METROPOLITAN GOVERNMENT OF NASHVILLE AND DAVIDSON COUNTY

Metropolitan Historic Zoning Commission
Sunnyside in Sevier Park
3000 Granny White Pike
Nashville, Tennessee 37204
Telephone: (615) 862-7970
Fax: (615) 862-7974

STAFF RECOMMENDATION
1608 Gartland Avenue
October 17, 2012

Application: Full Demolition; New Construction – Primary Building and Accessory Building

Non-contributing structure at 1608 Gartland Avenue.

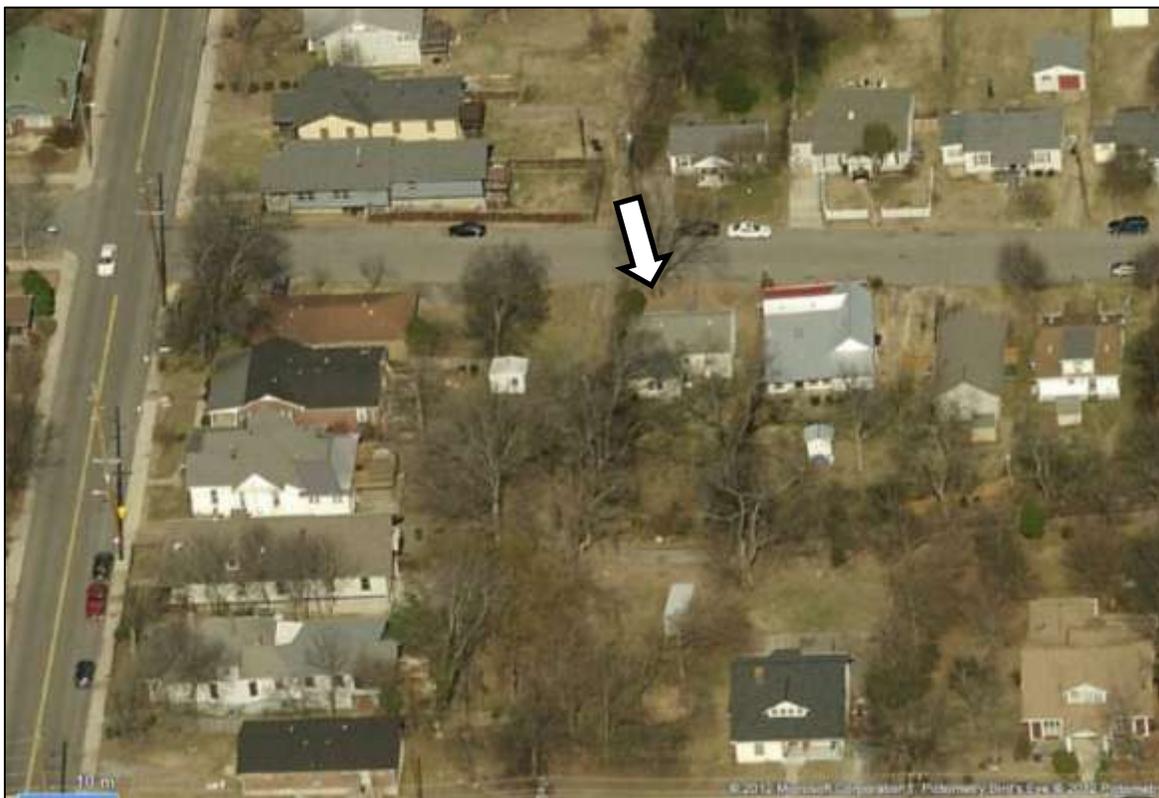
Because the existing structure does not contribute to the historic character of the district, the application to demolish meets guideline IV.B.2.b.

1 PROPERTY PLAN
 SCALE 1/32" = 1'-0"

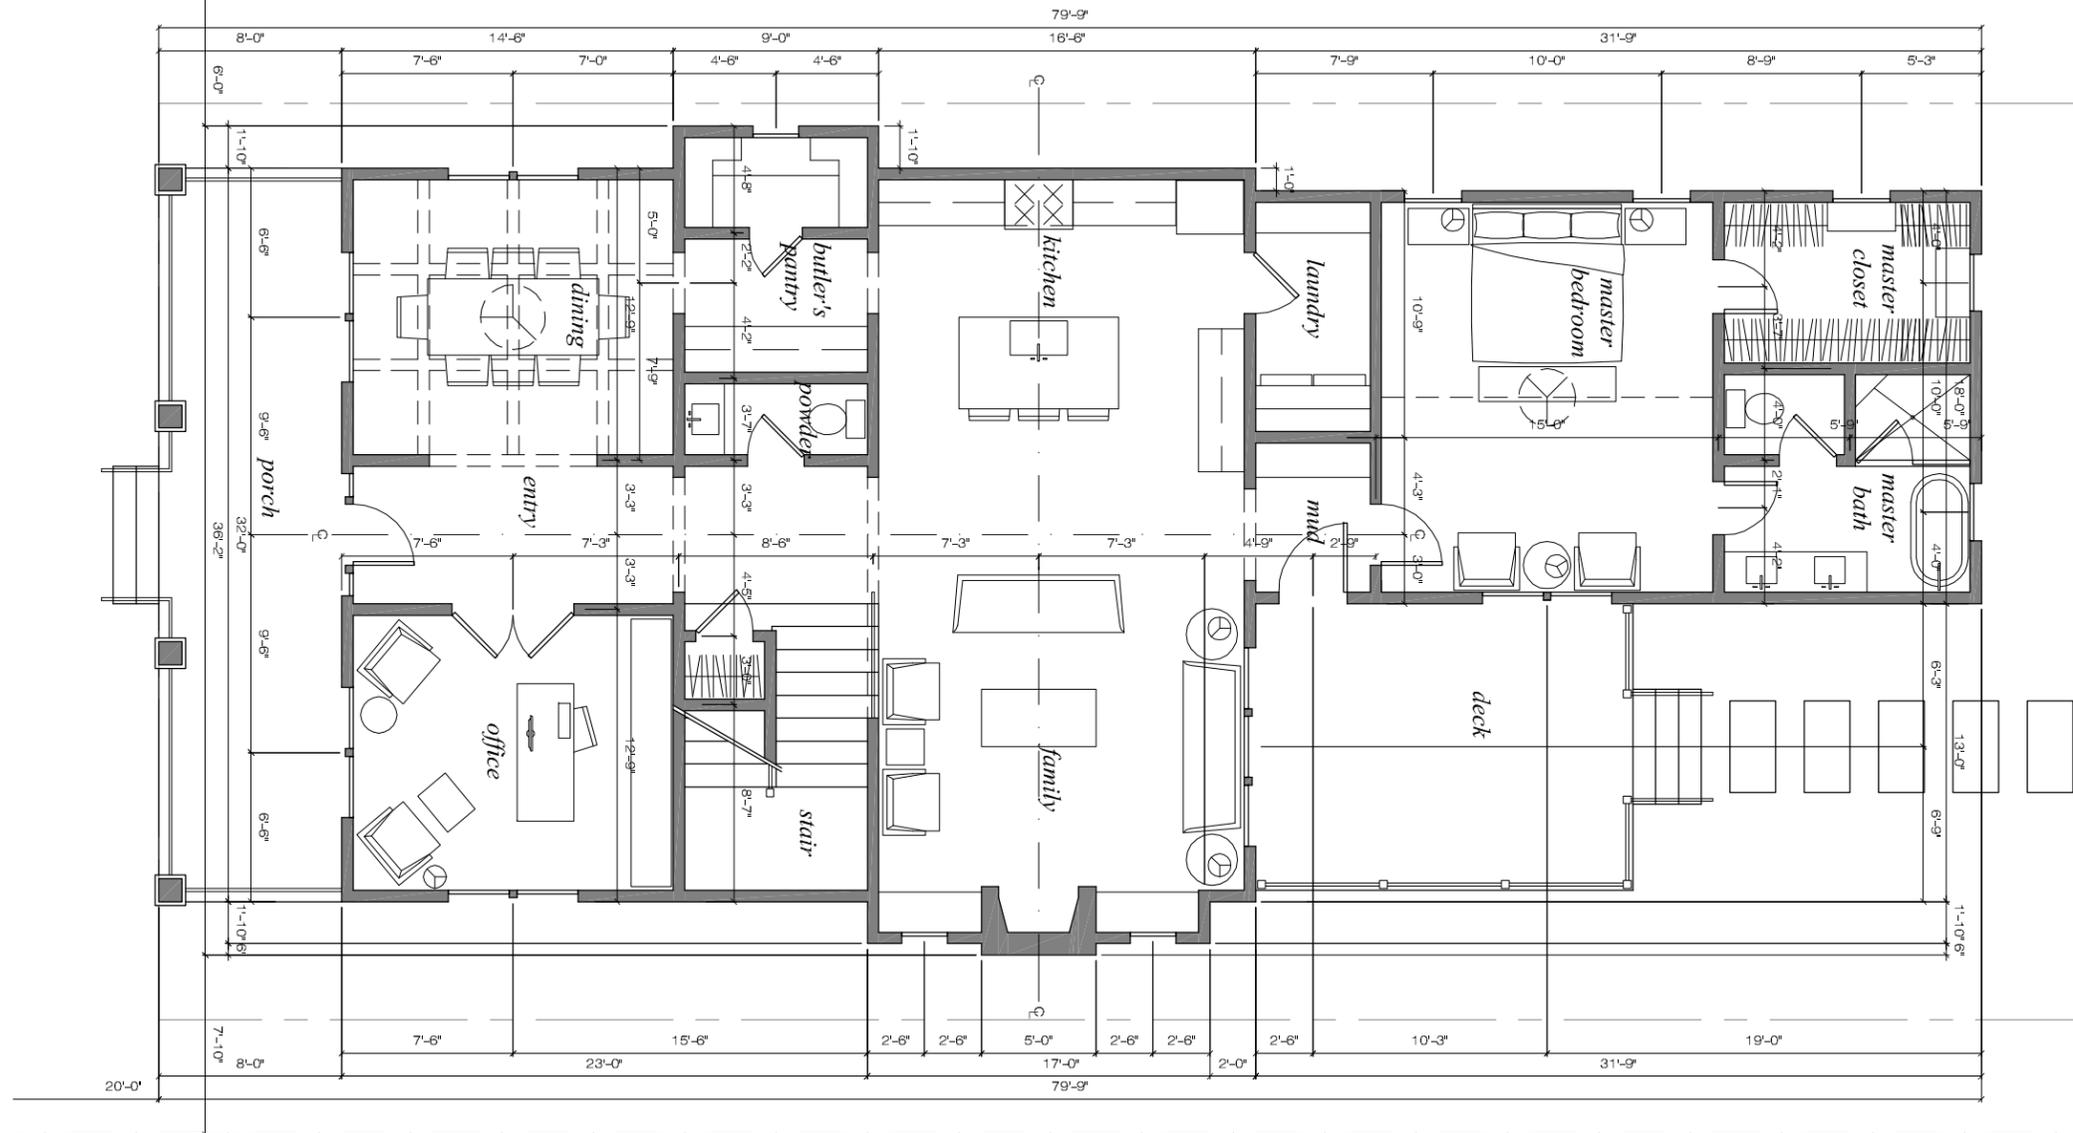
The house will be nearly centered on the lot with side setbacks of six and eight feet (6', 8'). The surrounding lots and houses are not uniform in size, but the setbacks range from four to eleven feet (4' – 11'). The front setback of the new house will be twenty-eight feet (28') to the leading edge of the porch. This will be ten feet (10') deeper than the adjacent Folk Victorian house to the left, but will be consistent with the majority of other historic houses on the street. The orientation of the house will match the surrounding historic context. Staff finds the proposed setbacks and orientation to meet guidelines II.B.3. and II.B.6.

The accessory structure will be accessed from the alley, with no driveway to the street. Staff recommends that a concrete walkway like that found on other houses in the area be added from the front of the structure to the street.

Recommendation: Staff recommends approval of the proposed demolition of a non-contributing structure, and the subsequent construction of a new primary building and accessory building, with the condition that staff approve the windows and that a concrete walkway be added from the front of the house to the street. With these conditions, Staff finds the application to meet the Lockeland Springs-East End Neighborhood Conservation Zoning Overlay.
